Addendum No. 01

Subject: Swenson Arts & Technology HS – CTE Improvements
SDP Contract Nos. B-120C, B121C, B123C of 2017/18

This Addendum, dated 17 of June, 2019, shall modify and become part of the Contract Documents for the work of this project. Any items not mentioned herein, or affected by, shall be performed strictly in accordance with the original documents.

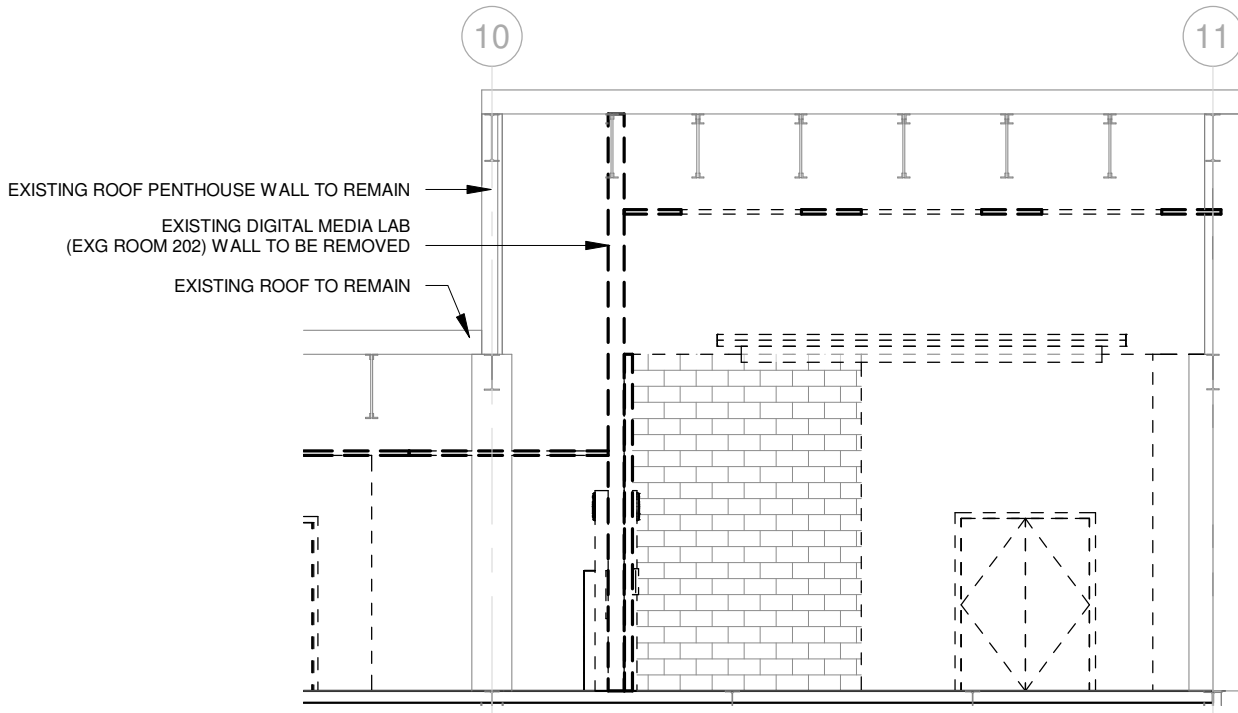
- a. ADDED phone jack to JROTC classroom.
- b. At AV Recording Studio #203- No outlets shall be located on the green screen wall (refer to architectural plans for location). Relocate all outlets currently shown on the green screen wall with the door to 20" within the door. All outlets on the other green screen wall shall be relocated to the exterior wall.
- c. Data System Notes - A note shall be REVISED as follows: " All fiber strands shall be terminated with **LC connectors**" (instead of ST connectors)

1 DIGITAL MEDIA LAB EXISTING WALLS
 A102 1/8" = 1'-0"

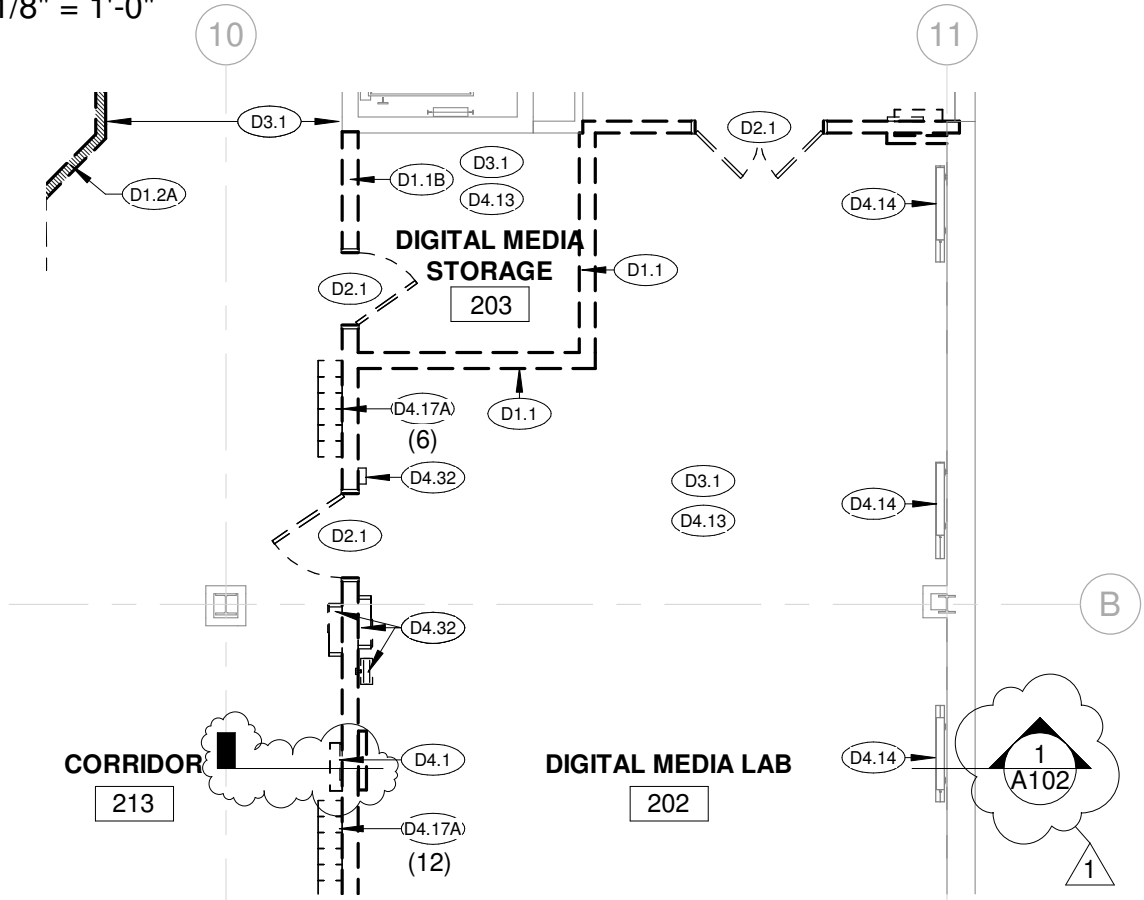
Q5: Please provide structural details and roof elevations at/over rooms 200A, 201, 203, 203A, 203B, 203C. A cross-section at "B" line from lines 9 to 11 would be very helpful.

A5: The existing corridor wall in the above-referenced rooms is a non-bearing CMU partition which is braced at decking. Refer to diagrammatic section ASK-01, attached.

1 SECOND FLOOR - DEMO PLAN
 A100 1/8" = 1'-0"

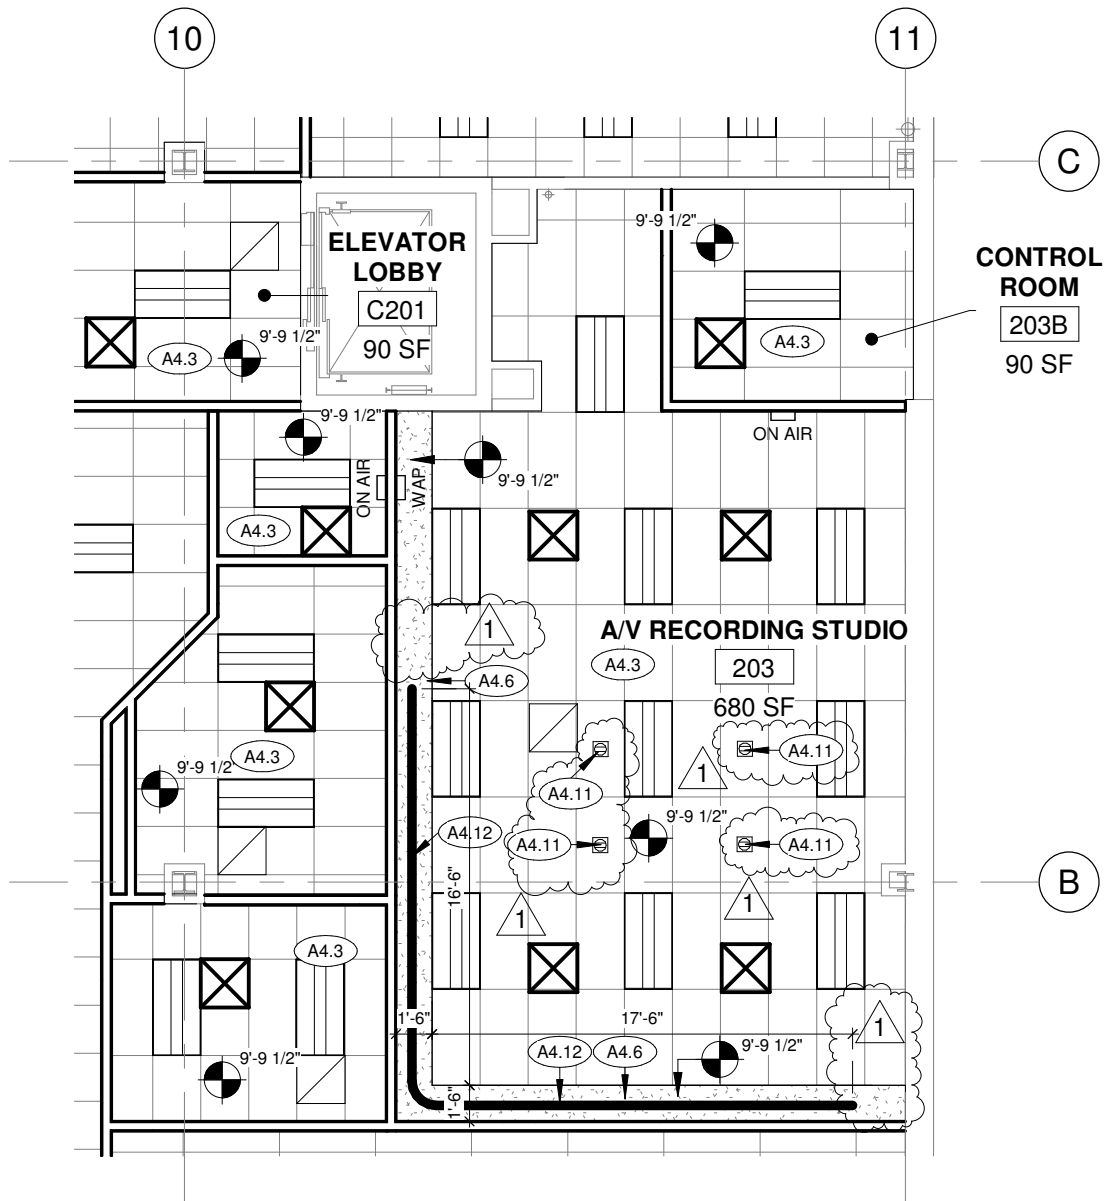
- a. In demo plan 1/A100, MODIFY keynote D4.2 in Tech Resource Center to read “PROTECT EXISTING DATA RACK TO REMAIN – SEE ELECTRICAL DRAWINGS FOR ADDITIONAL INFORMATION.”
- b. ADD reference section 1/A100. Refer to diagrammatic section ASK-01, attached.
- c. MODIFY view number for Second Floor – New Work Plan to 2/A100.

2 NEW WORK REFLECTED CEILING PLAN
 A101 1/8" = 1'-0"

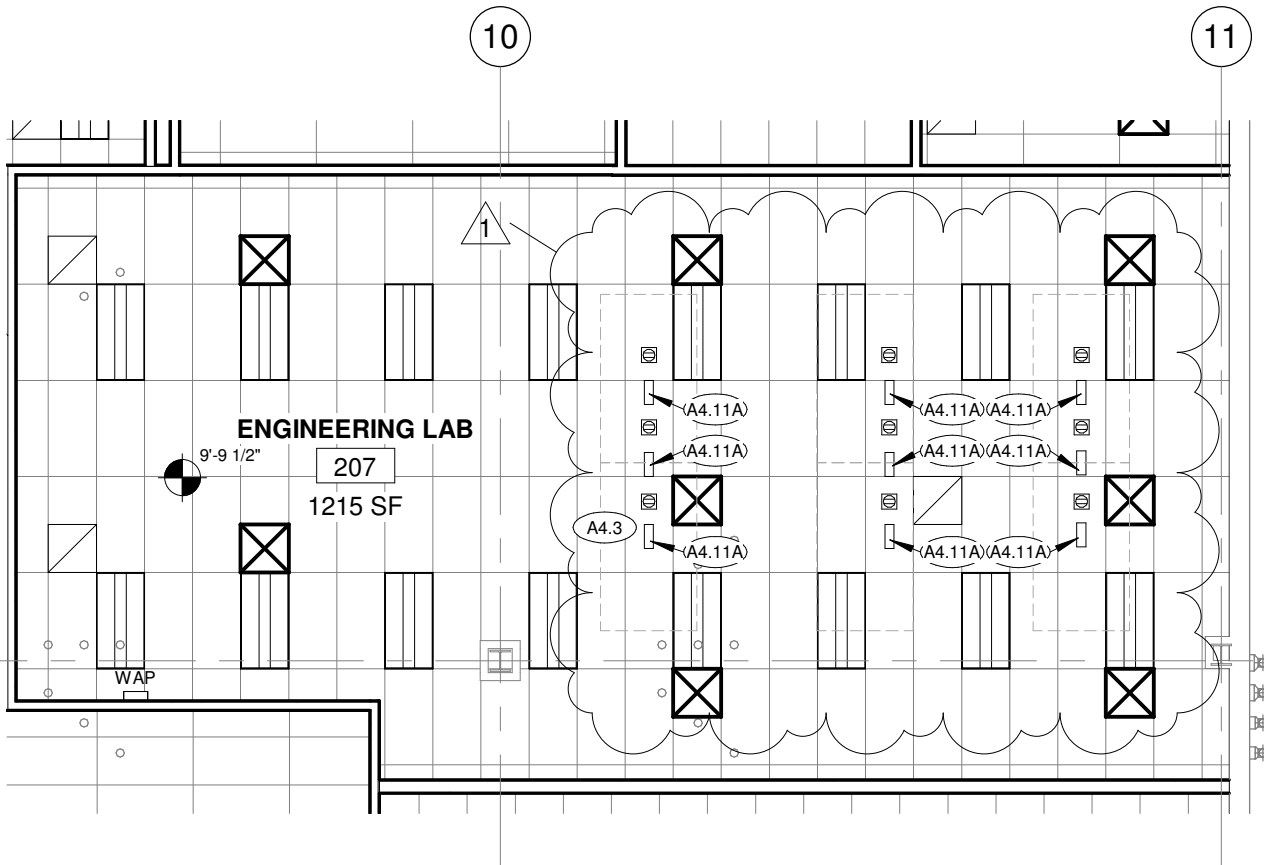
- a. MODIFY Keynote A4.11 to read: EC TO PROVIDE FIRE-RATED QUAD OUTLETS MOUNTED TO CEILING - COORDINATE FINAL LOCATIONS, SEE ELECTRICAL DRAWINGS AND ADDENDA FOR ADDITIONAL INFORMATION.
- b. ADD Keynote A4.11A to read: EC TO PROVIDE CORD REEL AND FIRE-RATED OUTLET MOUNTED TO CEILING - COORDINATE FINAL LOCATIONS WITH FURNITURE, SEE ELECTRICAL DRAWINGS AND ADDENDA FOR ADDITIONAL INFORMATION.
- c. On 2/A101, MODIFIED new ceiling outlet locations in AV Recording Studio 203 – refer to ASK-02, attached.
- d. On 2/A101, ADDED for clarity cord reels in Engineering Lab 207 – refer to ASK-03, attached.
